**COUNTY OF WESTCHESTER
NEW YORK
DIVISION OF ENGINEERING**

**ADDENDUM NO. 3
CONTRACT NO. 20-530**

**Infrastructure Rehabilitation – Phase 2
Playland Park
Rye, New York**

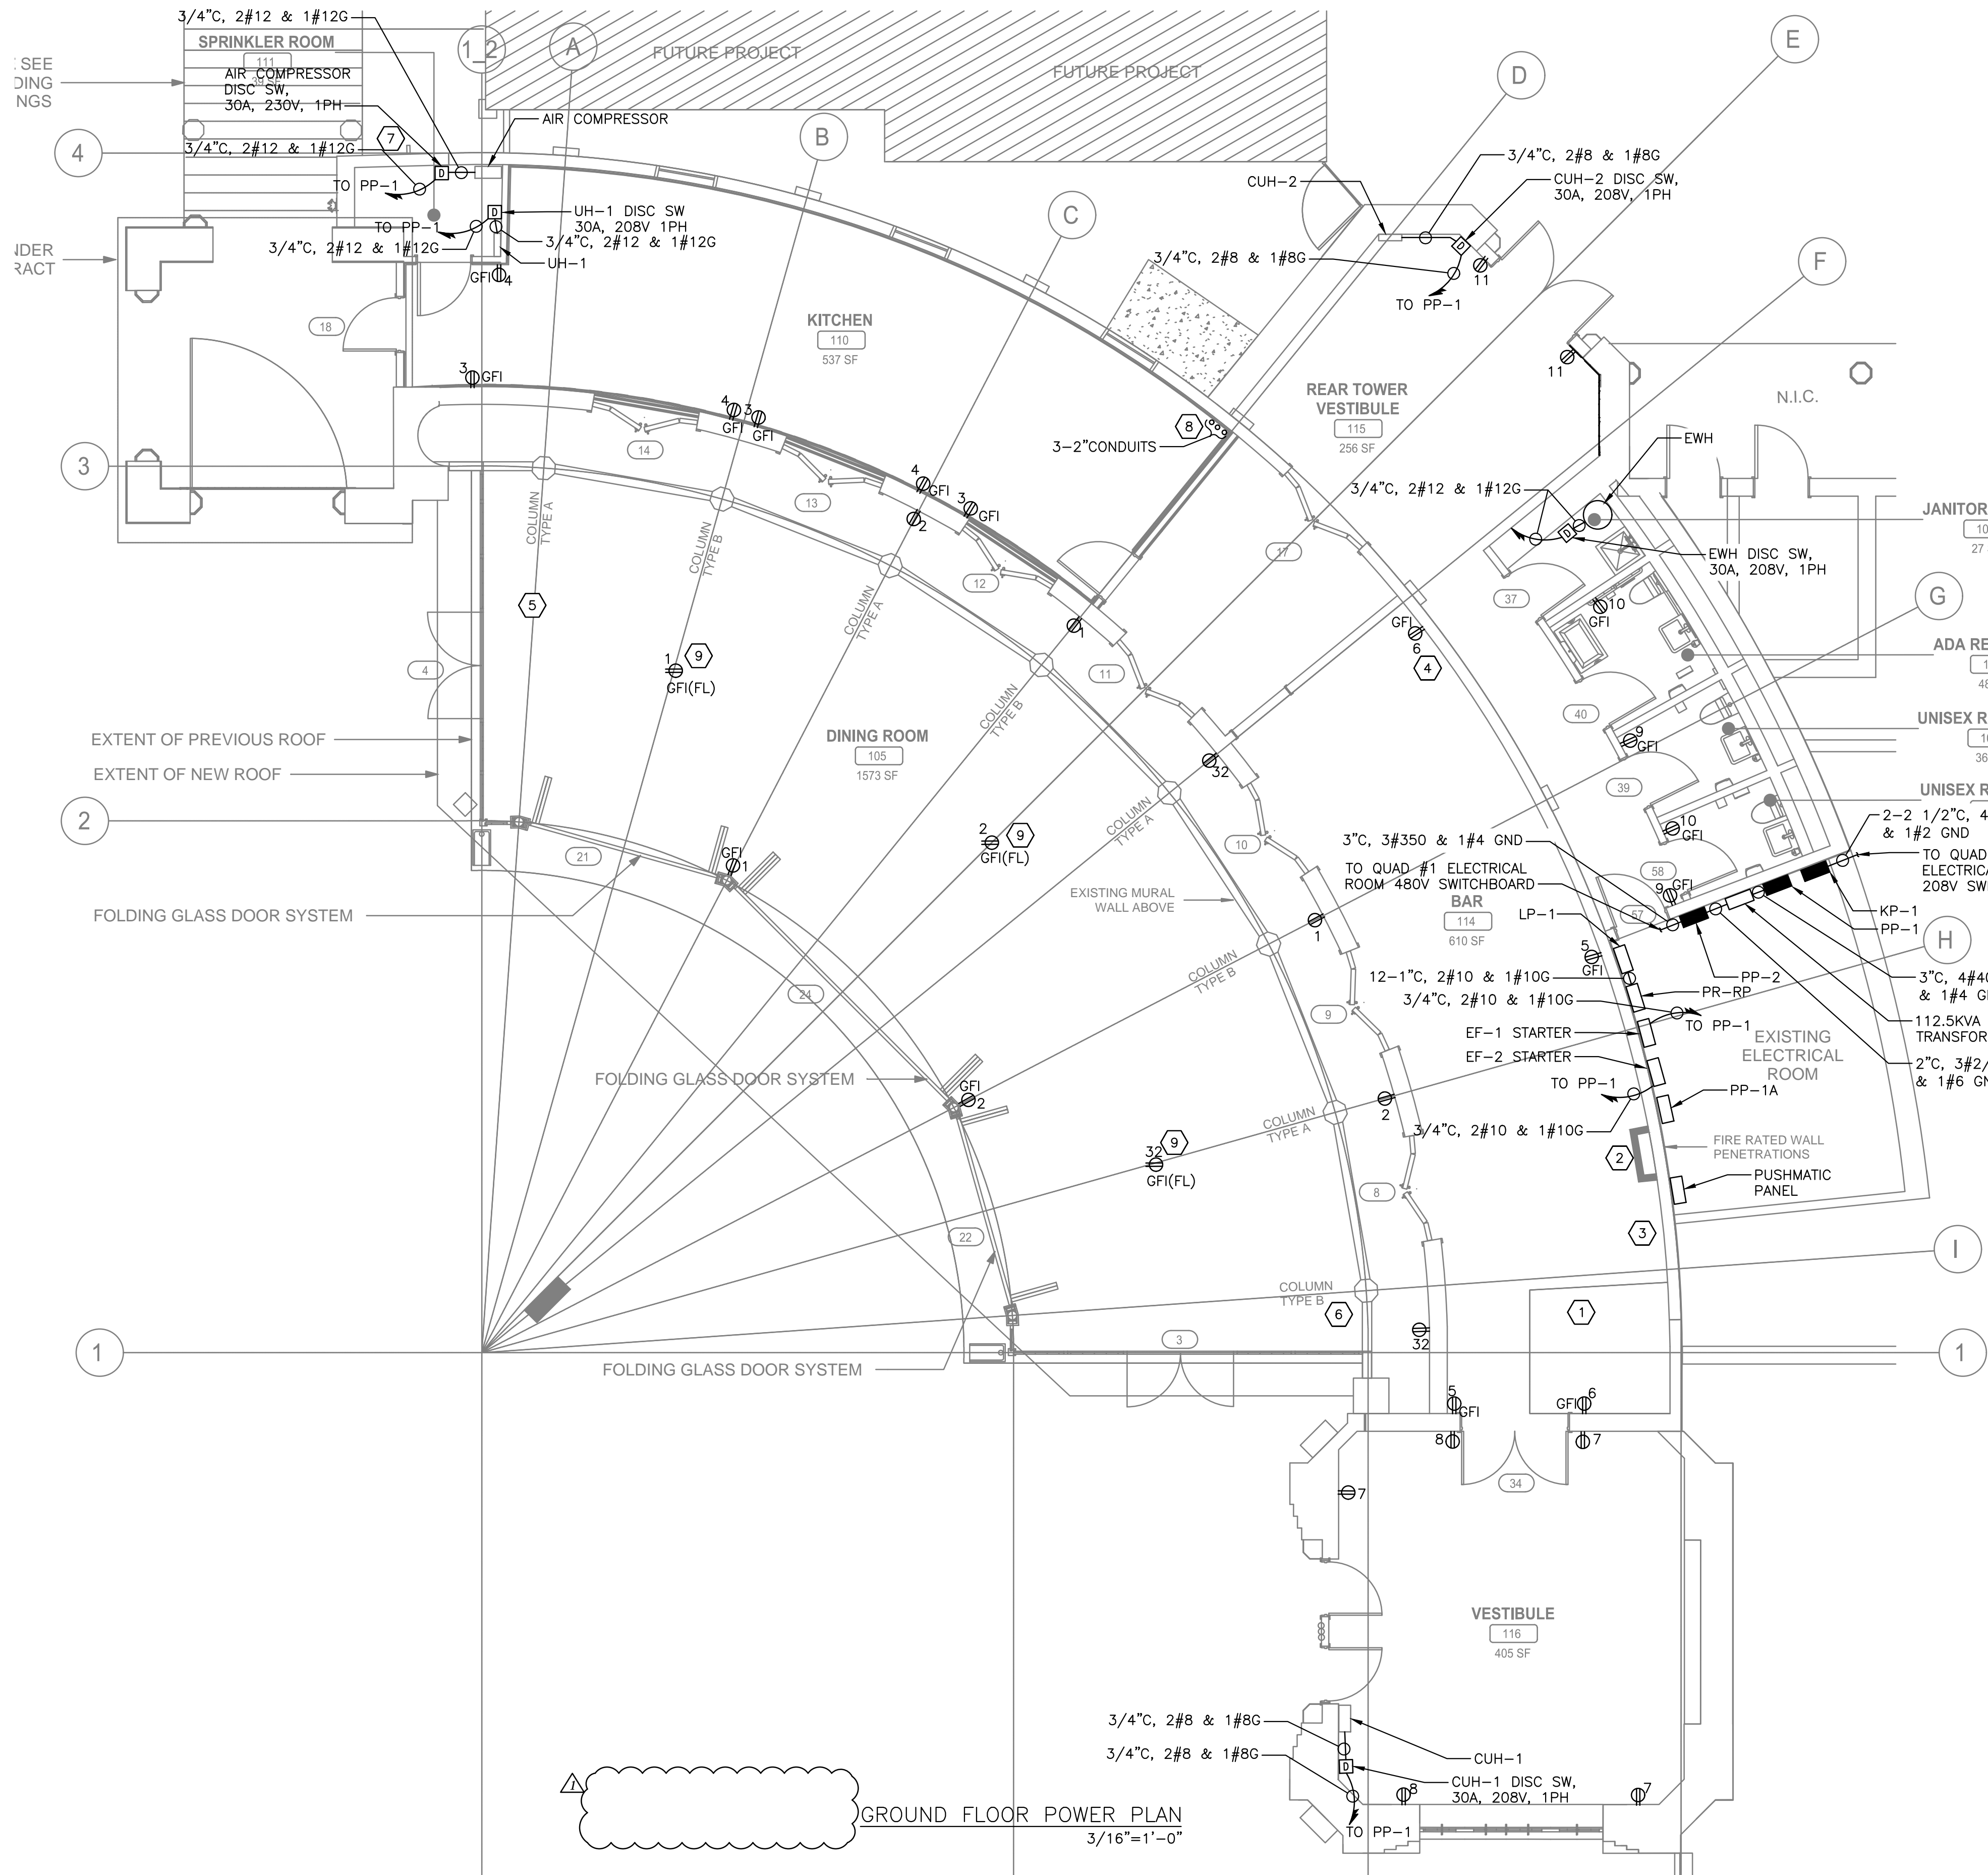
Item 12: Drawing PR-E-07 (Page 162), Ground Floor Power Plan
Modify the Contract drawing as shown on Addendum Drawing AD-PR-E-07, attached.

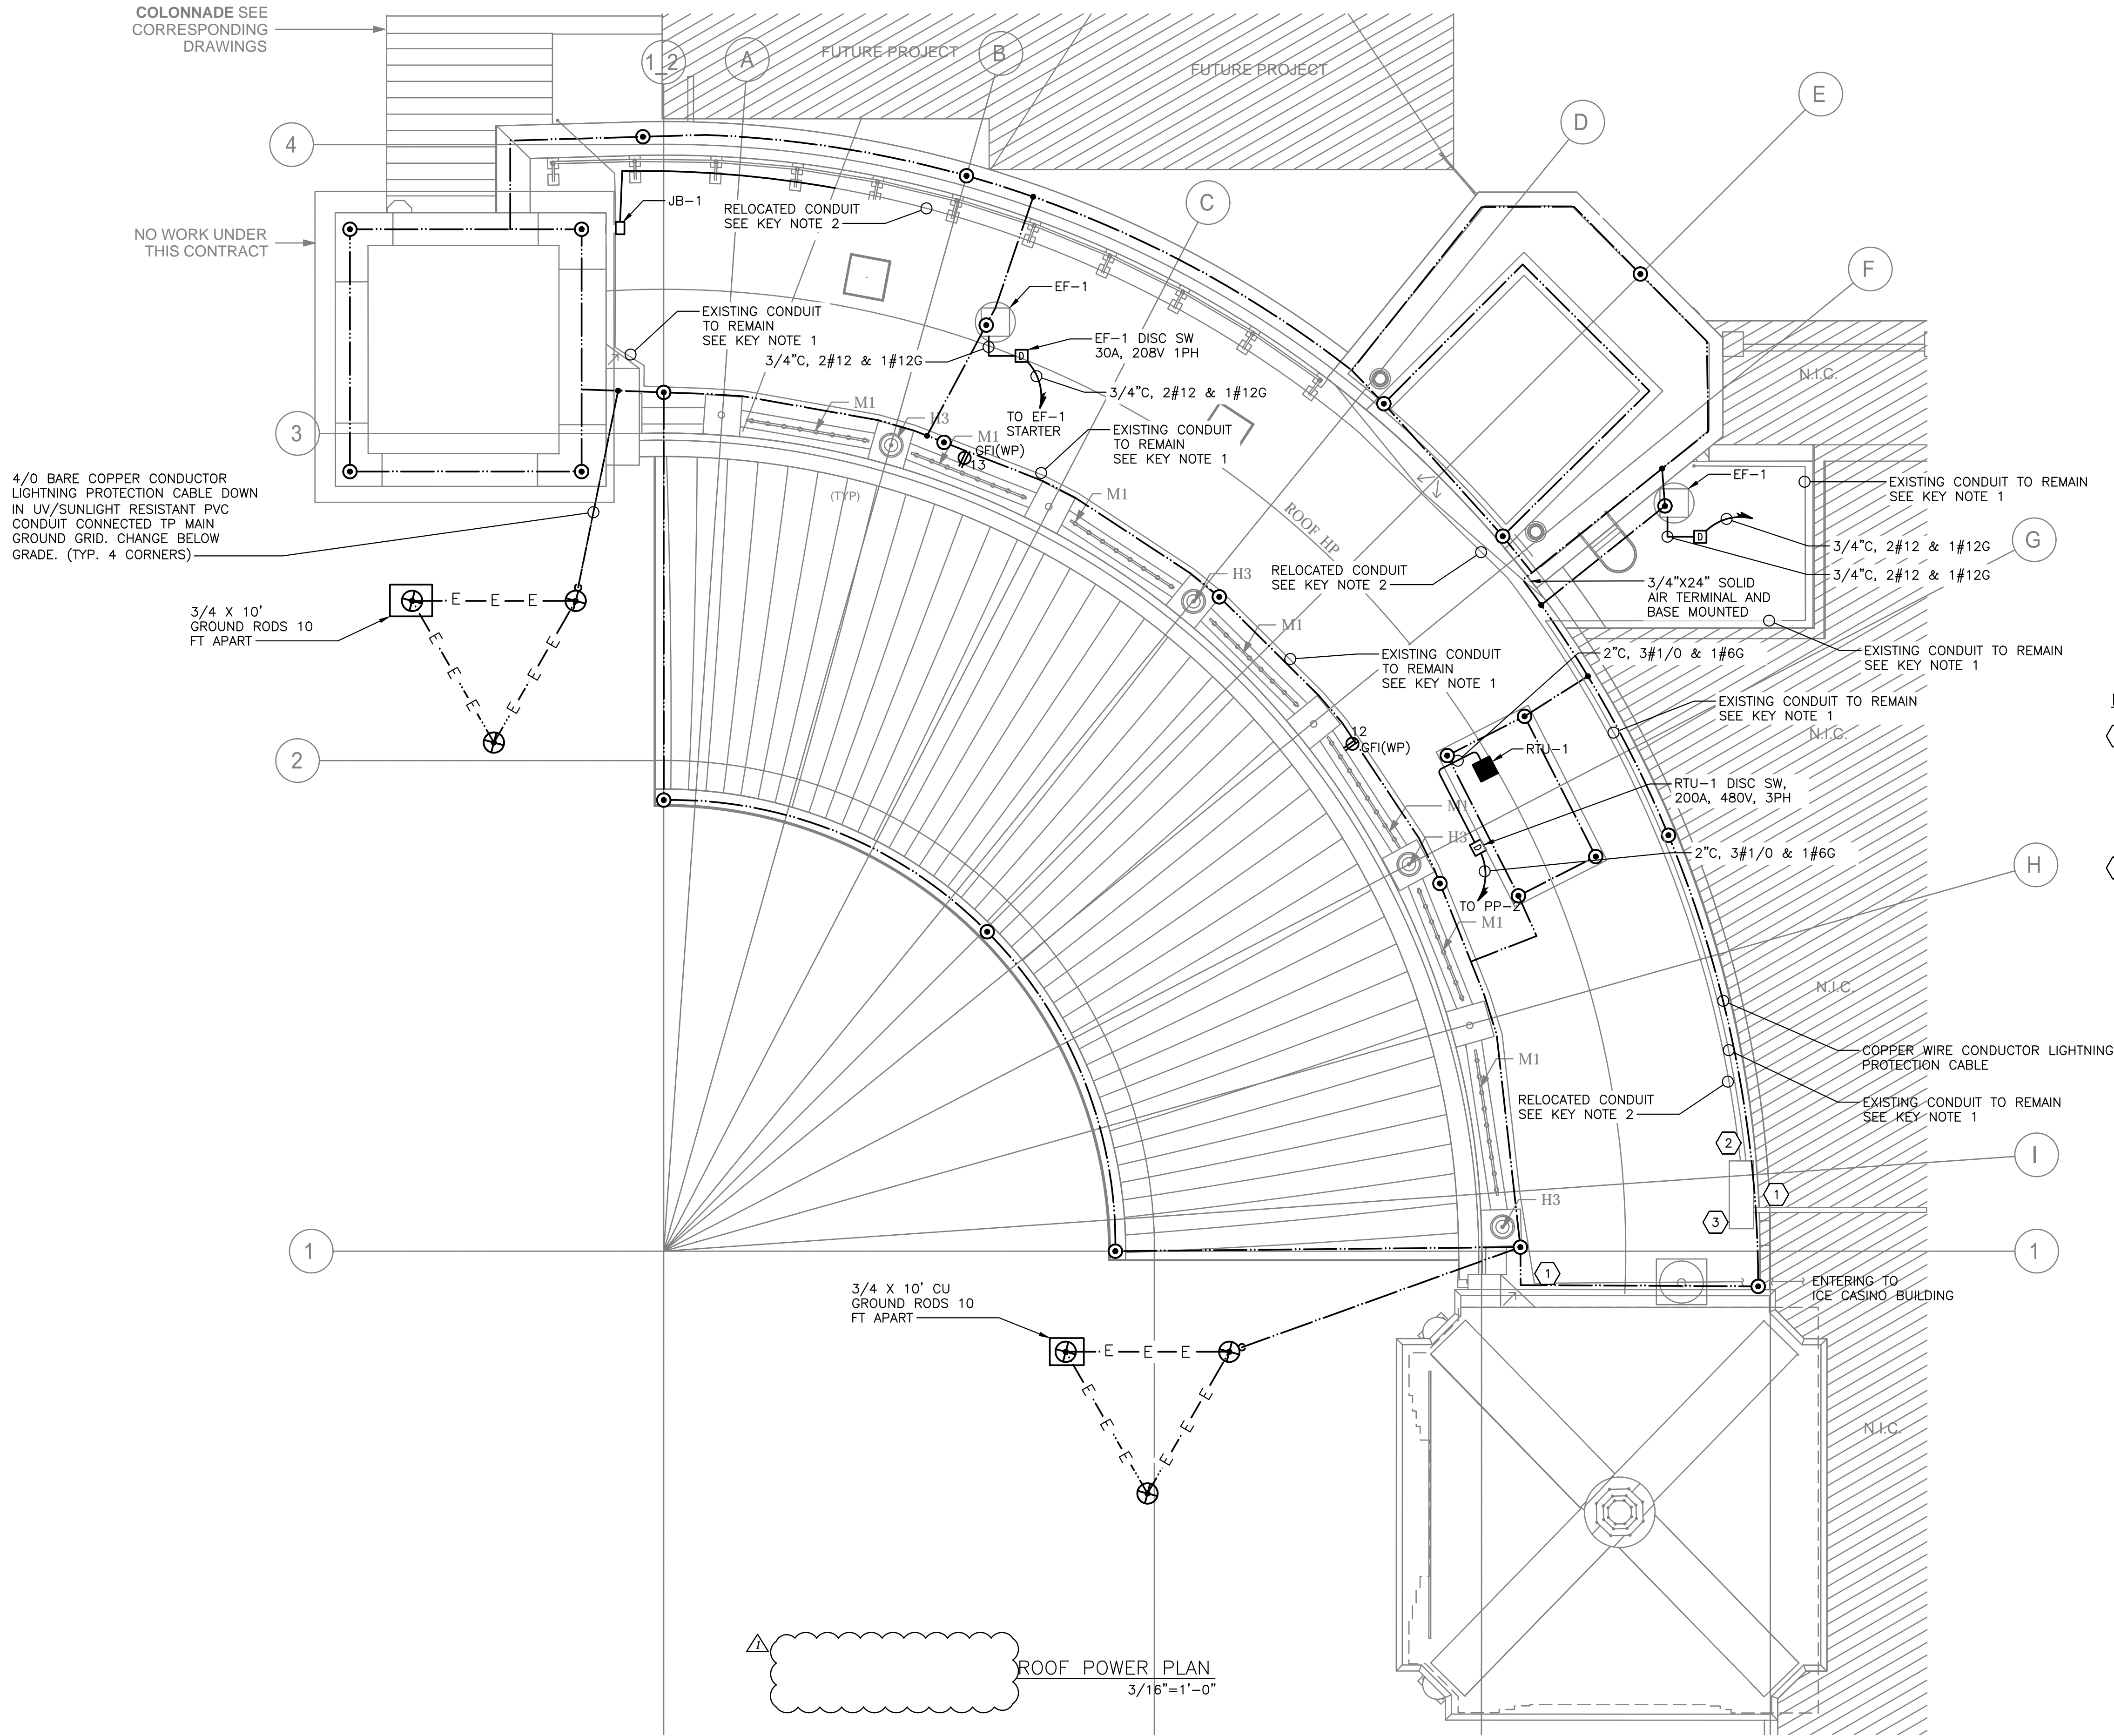
Item 13: Drawing PR-E-08 (Page 163), Roof Power Plan
Modify the Contract drawing as shown on Addendum Drawing AD-PR-E-08, attached.

CONTRACT NUMBER	SHEET NUMBER
20-530	AD-PR-E-10
DWG NO.: Page 165 of 290	
SCALE: AS SHOWN	
DATE: MAY 26, 2021	
DPW FILE NUMBER	REV. NO.
1-118-E-552	0

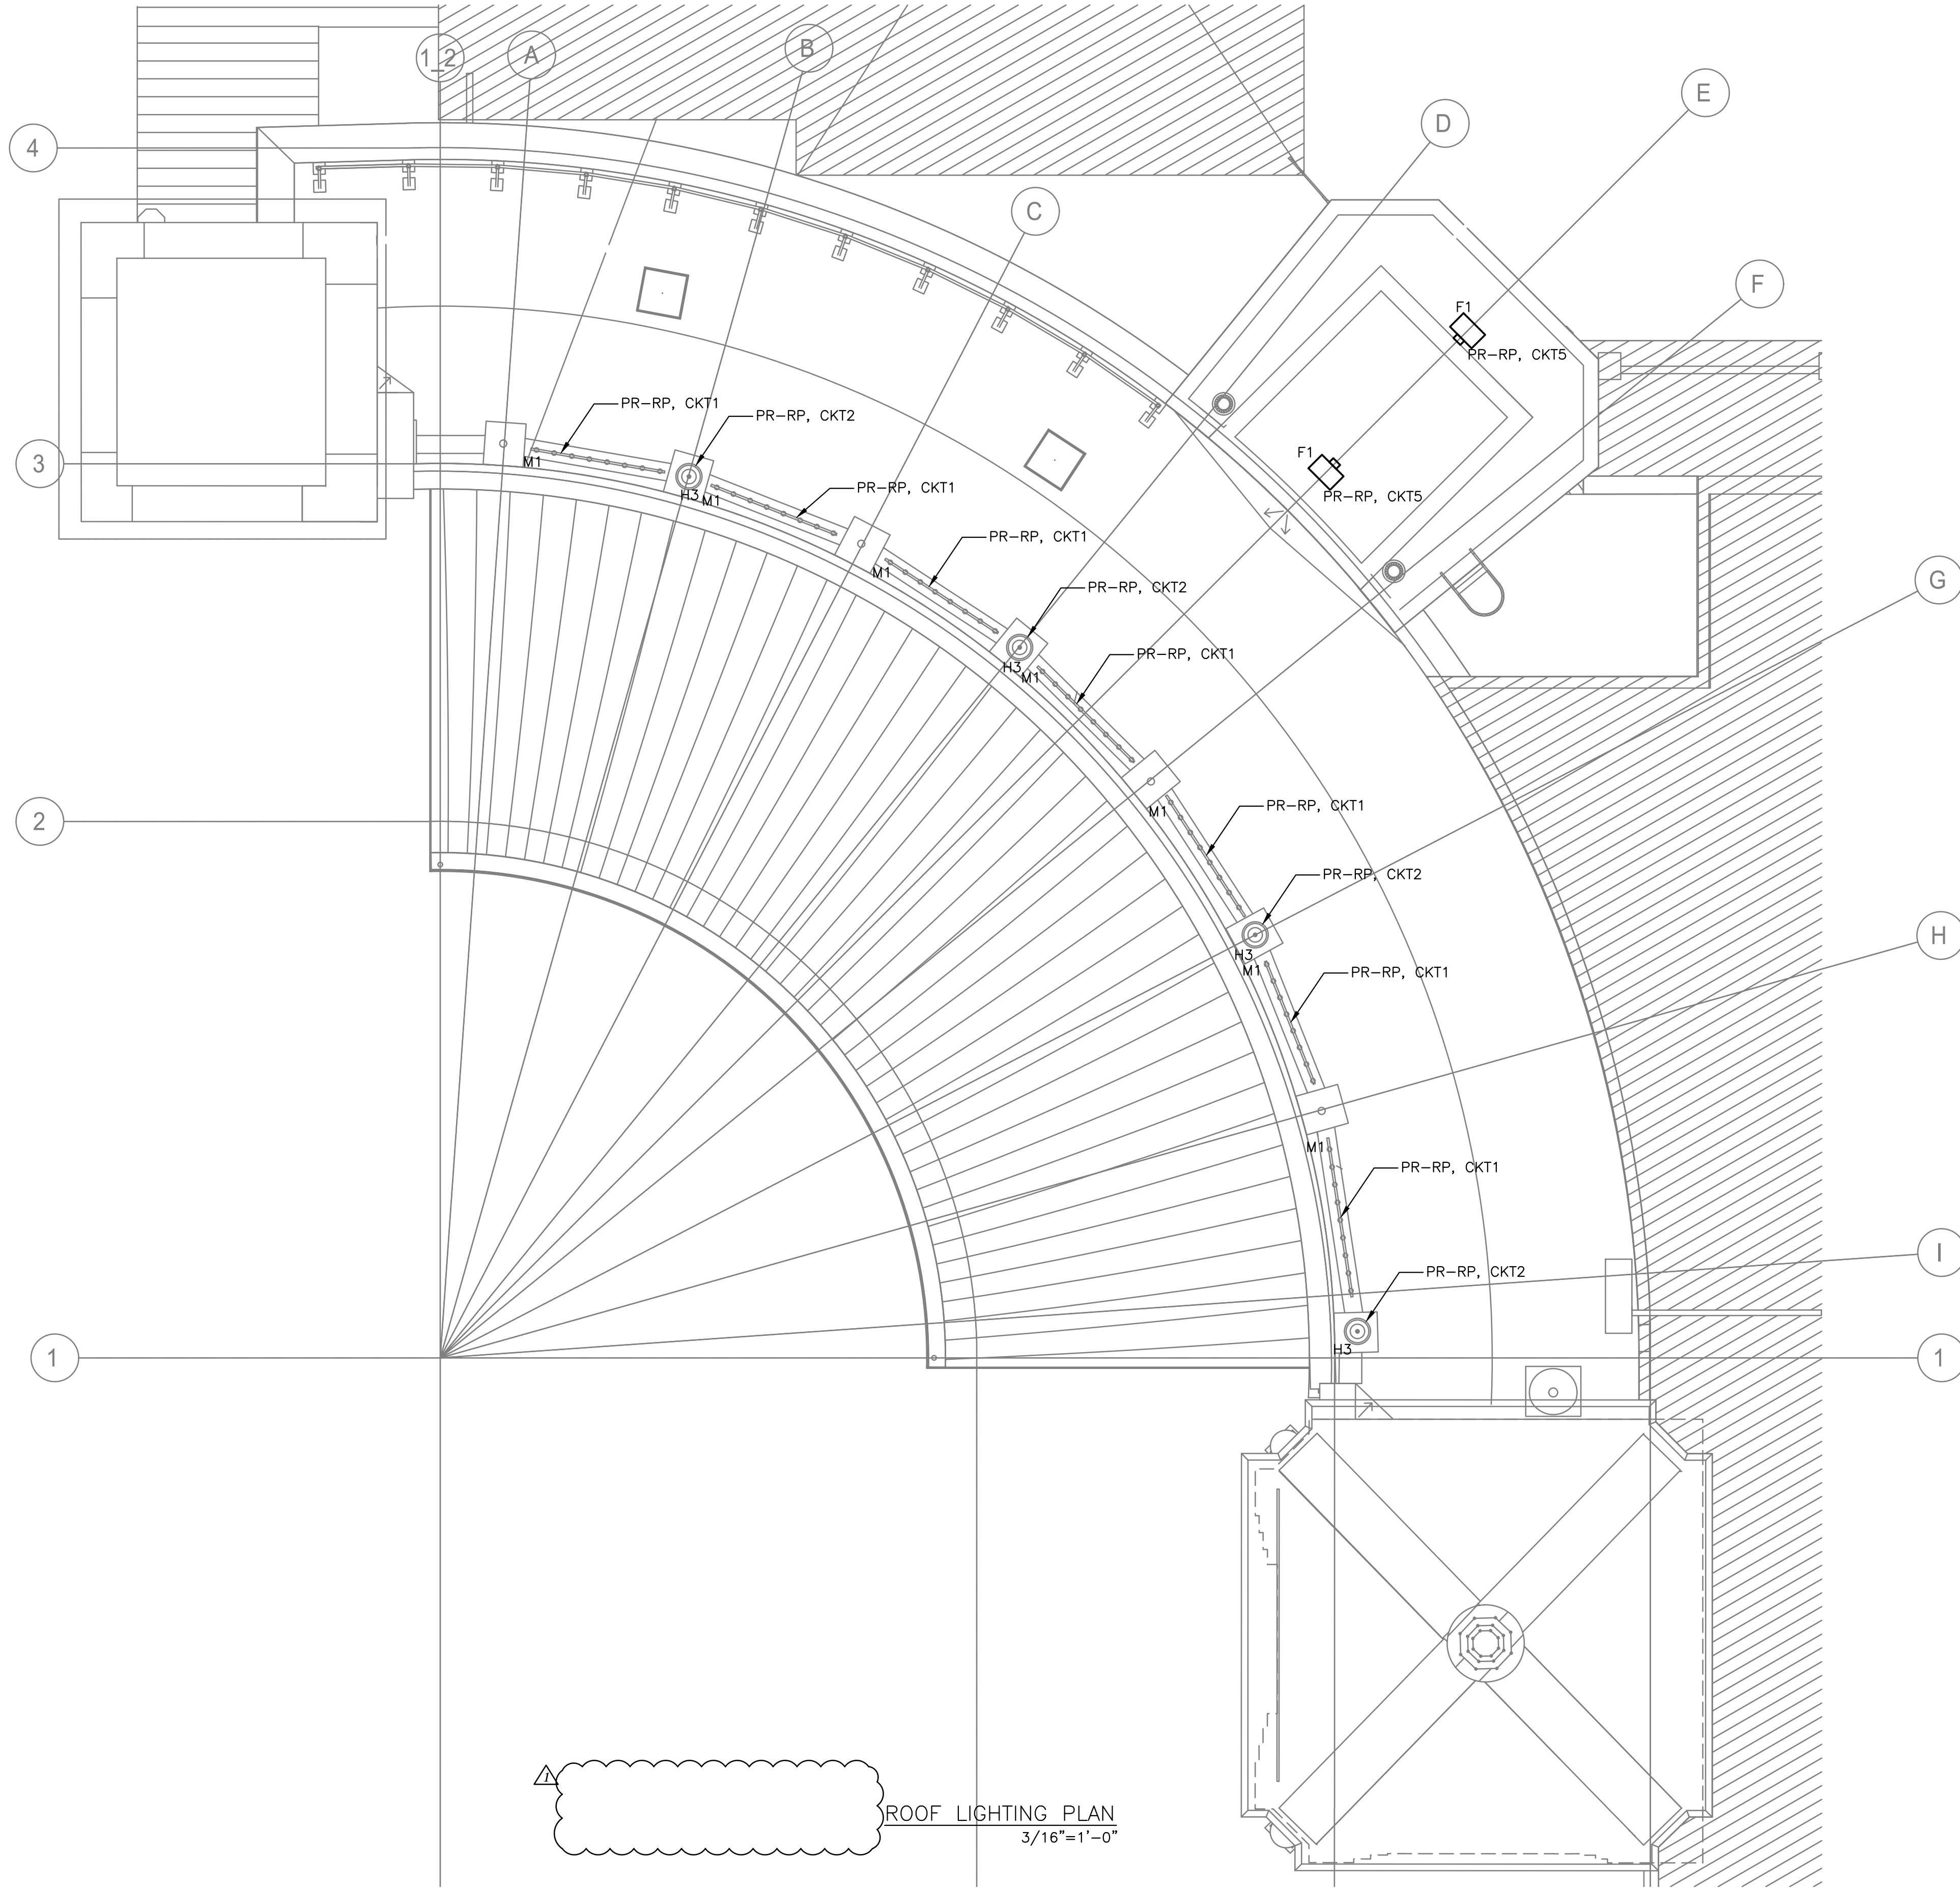
Item 14: Drawing PR-E-10 (Page 165), Roof Lighting Plan
Modify the Contract drawing as shown on Addendum Drawing AD-PR-E-10, attached.
